### From: Sent: 02 June 2020 14:15 To: Matthew Diamond <Matthew.Diamond@exeter.gov.uk> Subject: RE: Comments for Planning Application 19/1556/FUL

Address:	The Harlequin Centre Paul Street Exeter Devon EX4 3TT
Proposal:	Development of a Co-Living (Sui Generis) accommodation block and a hotel (Class C1) including bar and restaurant, following demolition of existing shopping centre and pedestrian bridge, change of use of upper floors of 21-22 Queen Street to Co-Living (Sui Generis), and all associated works including parking, landscaping, amenity areas, public realm improvements, new pedestrian bridge and provision of heritage interpretation kiosk. (Revised)
<b>Case Officer:</b>	Matthew Diamond

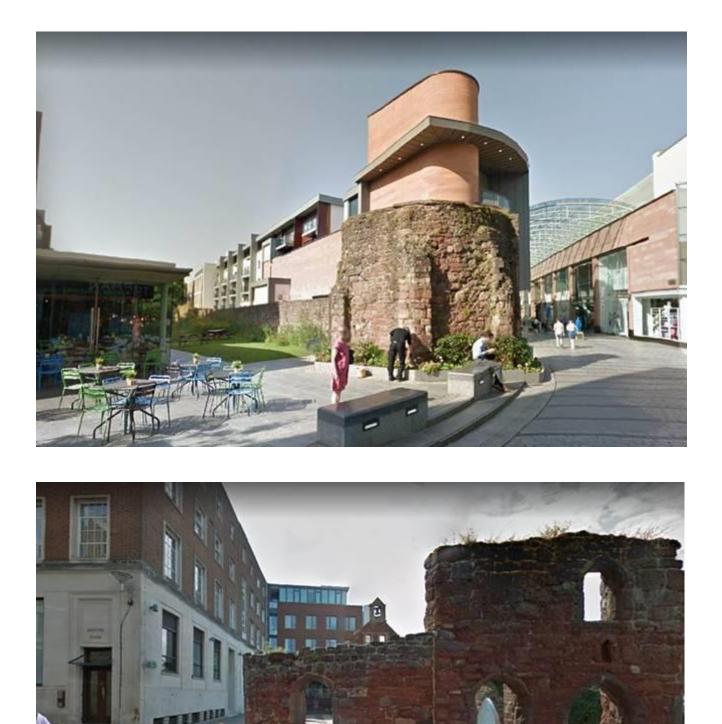
regrettable effect of overscaled buildings on The Close

cantilevered or jettied end impacts on wall, but not greatly

greatest impact of harlequin- still negligible by comparison with 7-storey proposals

harlequin all but invisible, wall dominates, 7 storey building would detract

Northernhay buildings impact of harlequin 3

Northernhay buildings impact of harlequin 4 greater impact but wall still dominant

Northernhay buildings impact of harlequin

site of proposed 7 storey structure 1

wall from Northernhay 1

wall near 17<sup>th</sup>-century house at foot of Northernhay

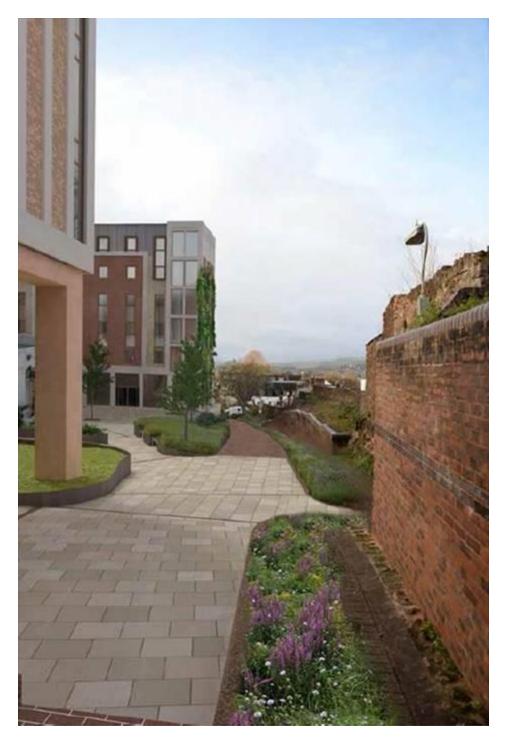
Thank you for your comments. You state that in your professional judgement the proposals will have a substantial impact on the scheduled wall and other heritage assets. The developer's heritage specialists state it is less than substantial. As a comparison to aid my understanding would you say that the relatively new buildings shown in the images below have a substantial or less than substantial impact on the scheduled monuments? NB. The bottom two images show visualisations of the proposal. I'm interested to know the subjectivity of this.

In all the photographs you attach I think it is self evident that the height of the modern buildings has a substantial and negative impact upon and detracts from the setting and significance of the of the city wall. I am not clear why you have included a picture of St Catherine's Almshouses, but the disparity of scale there between the remains of the almshouses and the Martin's Bank building is also unfortunate; however, this was a mistake made during post-war redevelopment and there is little that can be done about it now, other than to try not to perpetuate it elsewhere.

The new buildings in 'Roman Walk' are only five storeys high but they completely dominate the city defences as seen from the rear of Broadwalk House. In the case of the eastern angle tower, at the upper end of Princesshay, the new building completely overbears the surviving tower. Its attempt to reference some sort of tower structure really does not help, but reduces the genuine historic tower to a toy-like scale. This is further exacerbated by the raising of the ground levels outside the wall by several metres. This has buried a large part of the original external face of the defences which, even in my own childhood, retained something of their former impressive height. The wall has thus lost nearly all its former prominence and strength. The proposal for seven-storey buildings at Paul Street is likely to be even more destructive than this, as the developers drawings show and as should be evident if you mentally add two storeys to your photographs of the Princesshay buildings.
